Product Change Notification

Change Notification #: 113631-00
Change Title: Intel® Compute Module HNS2600JFQ
PCN113631-00, Product Design
Change the material of tray latch cap from
rubber to polycarbonate
Date of Publication: February 11, 2015,

Intel is implementing the following change on the Intel® Compute Module HNS2600JFQ:

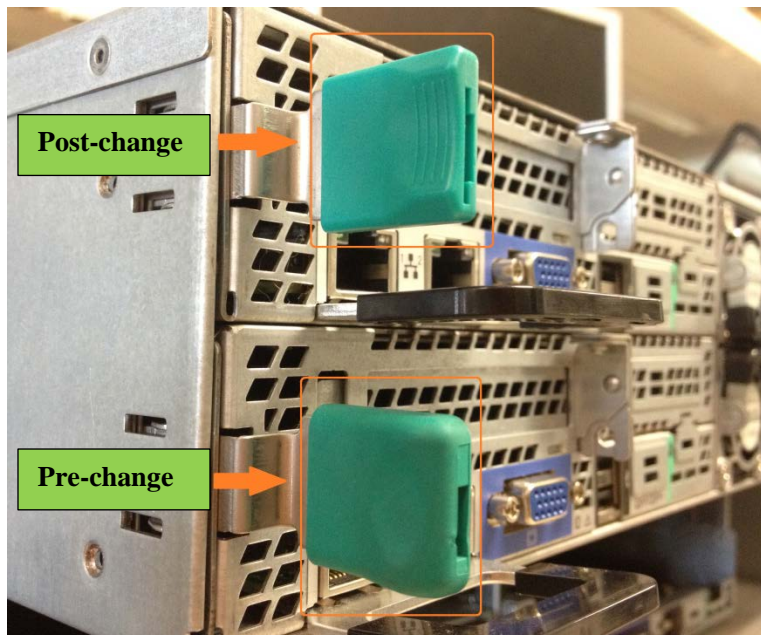
Change the material of tray latch cap from rubber to polycarbonate to avoid pulling the cap out from the tray latch.

See below picture: the lower one is pre-change cap and the upper one is post-change cap.
